# Service Bulletin

**SUBJECT:** Service Update for Inventory and Customer Vehicles  
Front Seat Cushion Trim Retention  
Expires with Base Warranty

**MODELS:** 2013 Cadillac XTS

Subject: 12290A – Service Update  
Front Seat Cushion Trim Retention  
Revised Service Procedure

2910856

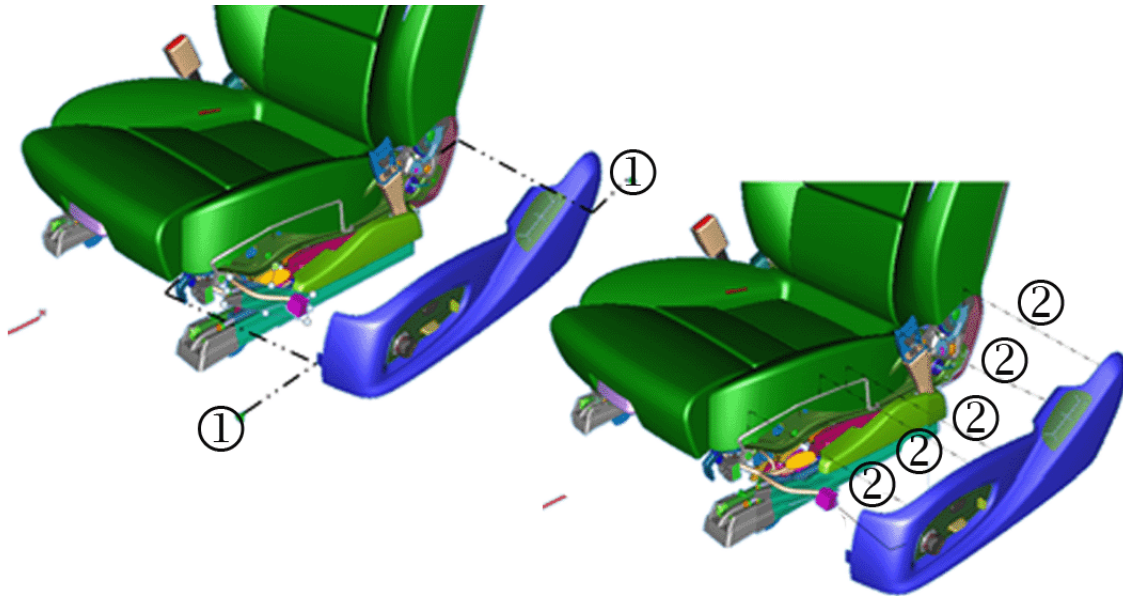
**Step 2 of the service procedure and the illustration for Steps 3 and 7 have been revised. Please discard all copies of bulletin 12290.**

2. Remove the front seat adjuster finish cover (1). Refer to *Driver or Passenger Seat Adjuster Finish Cover Replacement* in SI. The knobs do not need to be removed because the switch(s) will remain attached to the Adjuster Finish Cover. After removing the screw, the Adjuster Finish Cover must be gently pulled upwards to release the hook features. Use care to avoid pulling on electrical wiring prior to disconnecting the switch(s). Once the switch(s) on the Seat Adjuster Finish Cover is disconnected, the cover can be removed to allow access to the seat cushion cover for repair.

3350732

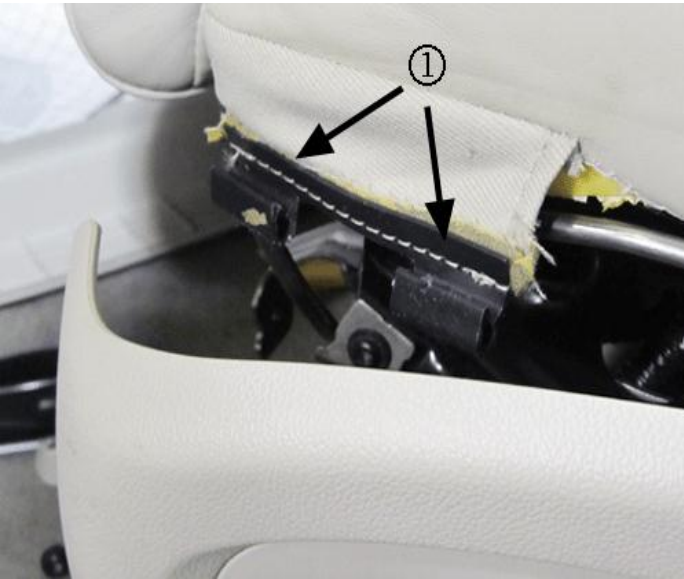
Step 2 of the service procedure and the illustration for Steps 3 and 7 have been revised. Please discard all copies of bulletin 12290.

3. Starting the outboard side repair, remove the front screw (1) retaining the seat cushion outer finish panel (2) and detach the front half of the panel from the seat frame.
